CITY OF CORCORAN  
**Corcoran Planning Commission Agenda**  
**June 4, 2020 - 7:00 pm**

**1. Call to Order / Roll Call**

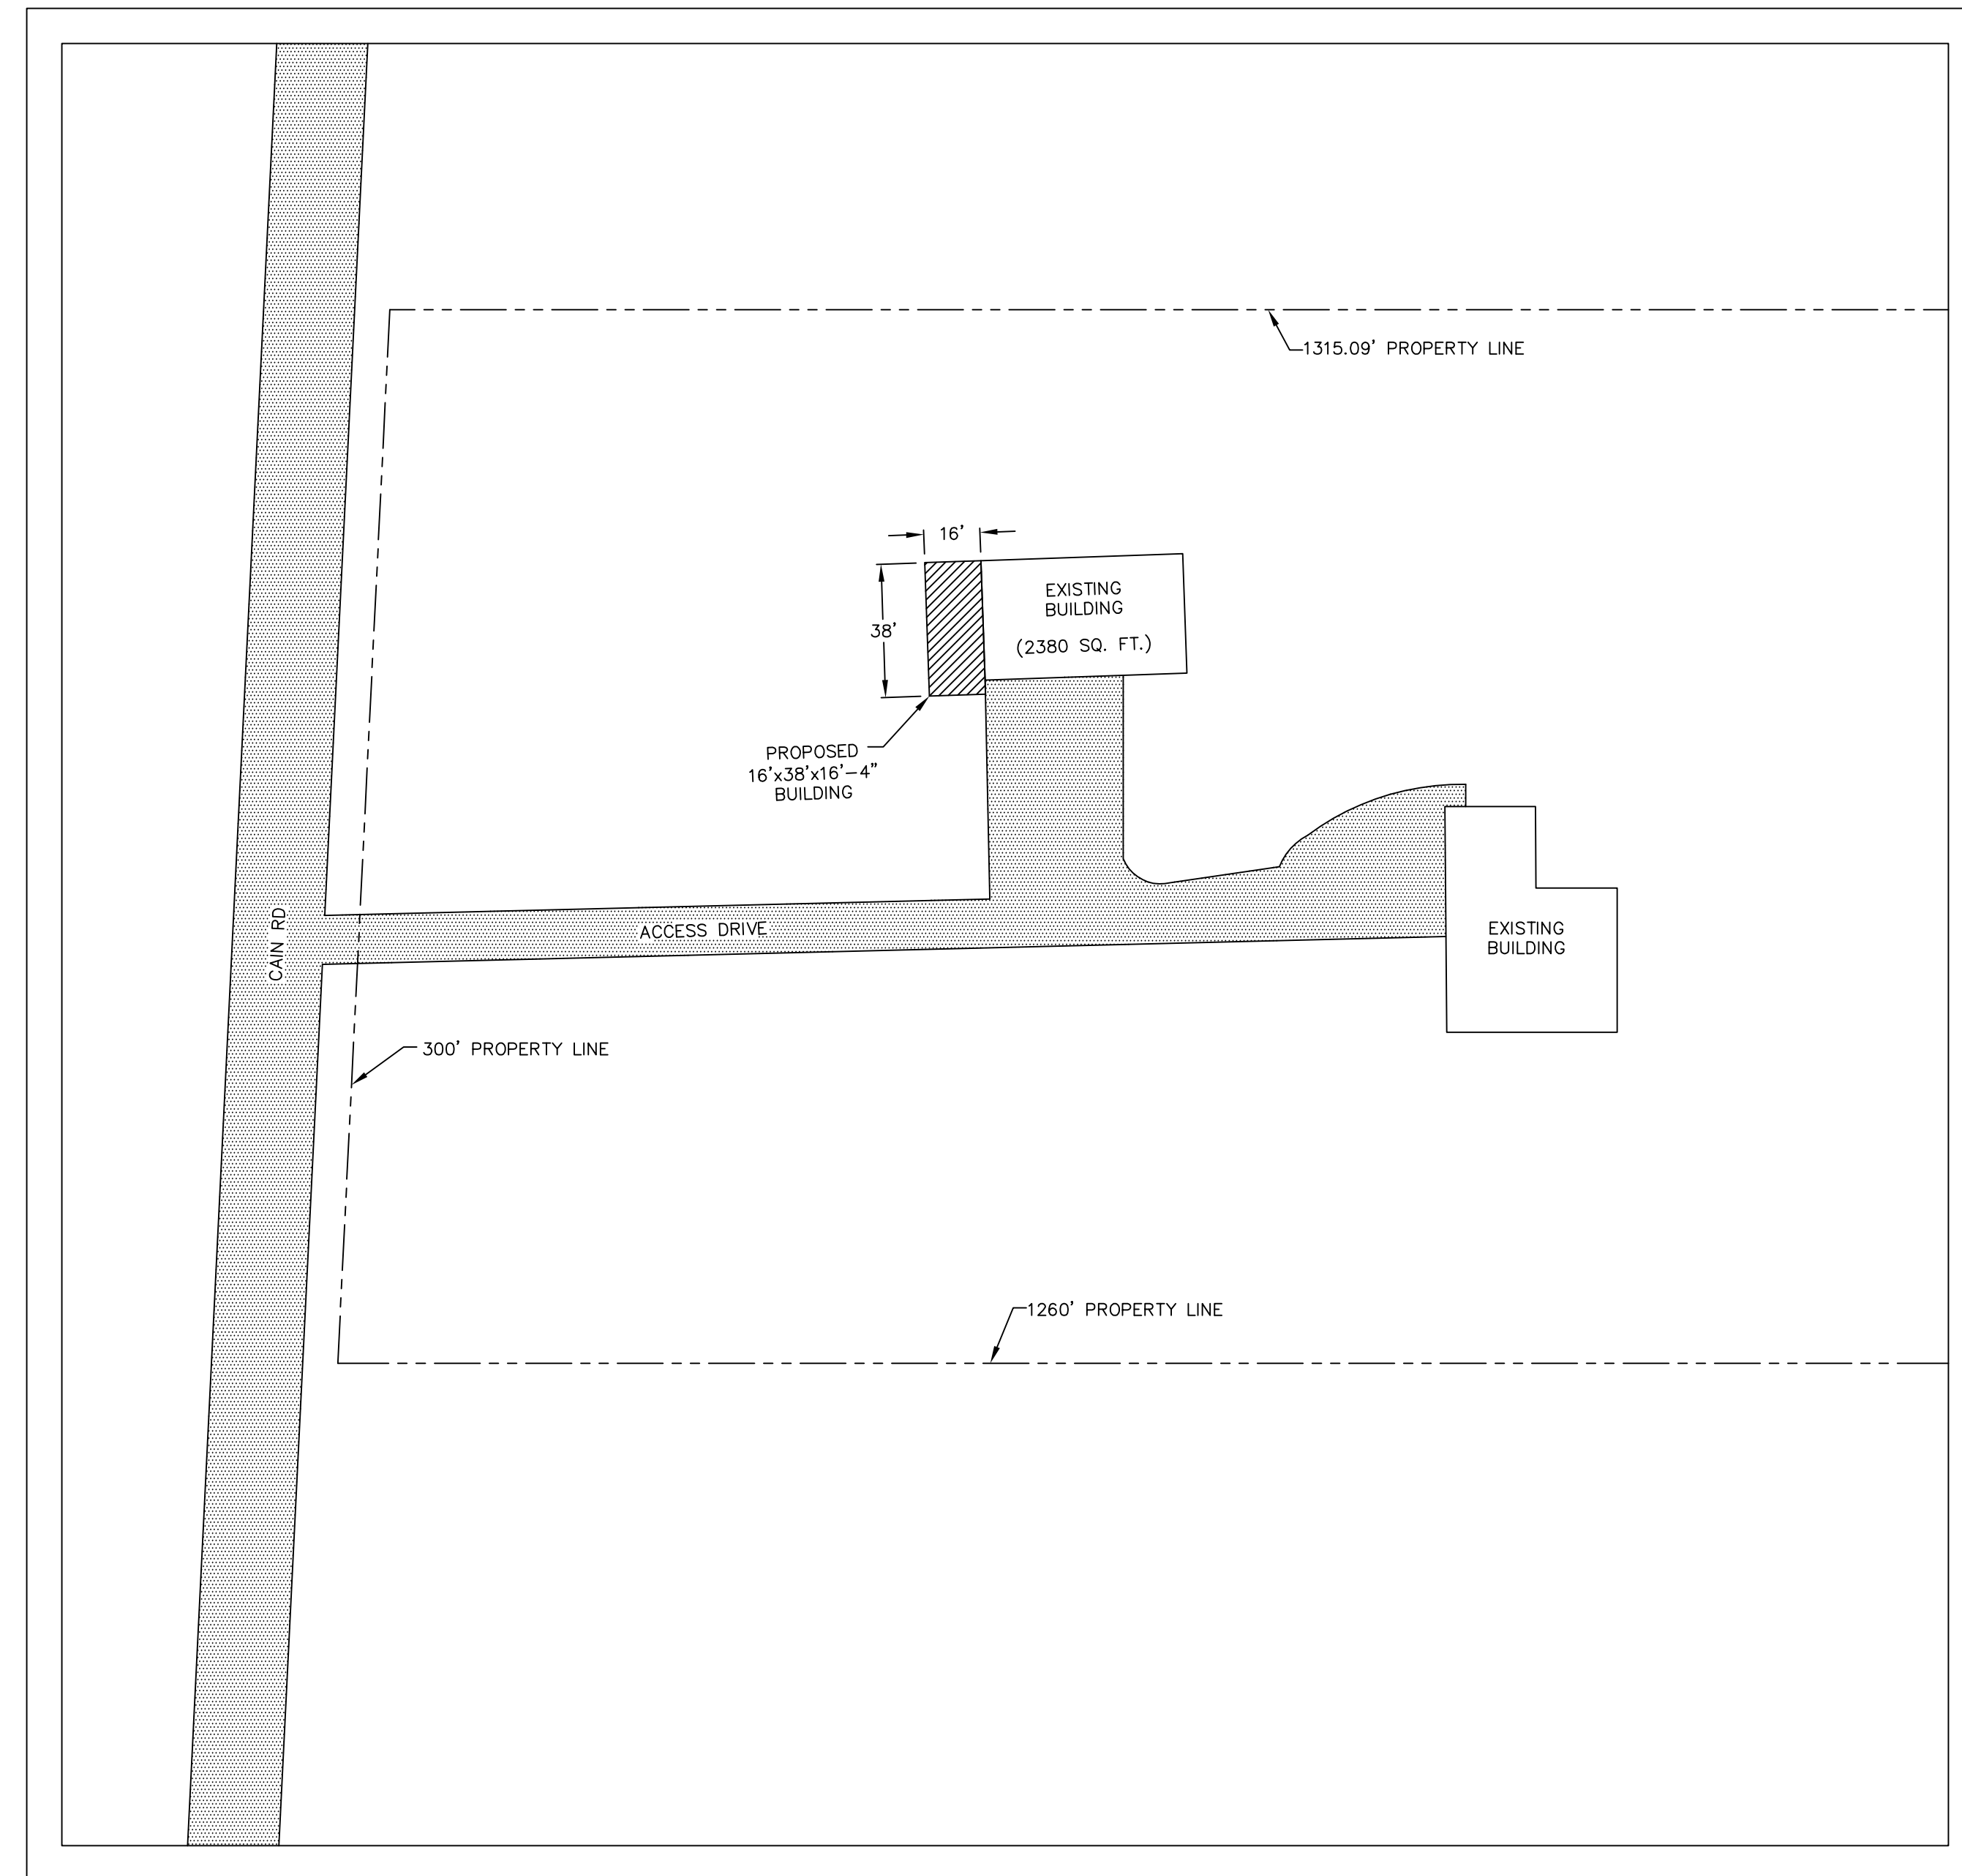
- PLEASE NOTE:
- DESIGNER LIABILITY LIMITED TO THE PREPARATION OF THE DRAWINGS WITH THE PARAMETER CONTRACTED AND ASCERTAINING TO CODE COMPLIANCE.
  - THESE DRAWINGS ARE DIAGRAMMATIC AND SHALL NOT BE SCALED. ADDITIONAL DATA SHALL BE RECEIVED FROM THE ENGINEER THROUGH WRITTEN CLARIFICATION ONLY. VERIFY ALL EXISTING CONDITIONS, ELEVATIONS, & DIMENSIONS BEFORE PROCEEDING WITH ANY PORTION OF ANY WORK.

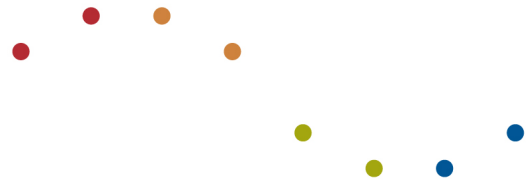
review and approval by the City. The plans must be revised to show compliance with these requirements.

It appears that several of the building pads overlap the structure setback requirements; however, they are pad sites not floorplans. Staff has provided the redlined version of the plans to the applicant showing where the constrained lots are and where consideration must be given the home style planned for those lots. PUD flexibility from these standards are not requested or recommended.

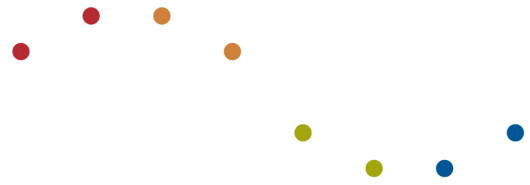
The plans must be revised to show the shoreland overlay district, the ditch and all required buffers on preliminary plat. The buffers must be protected by a drainage and utility easement.
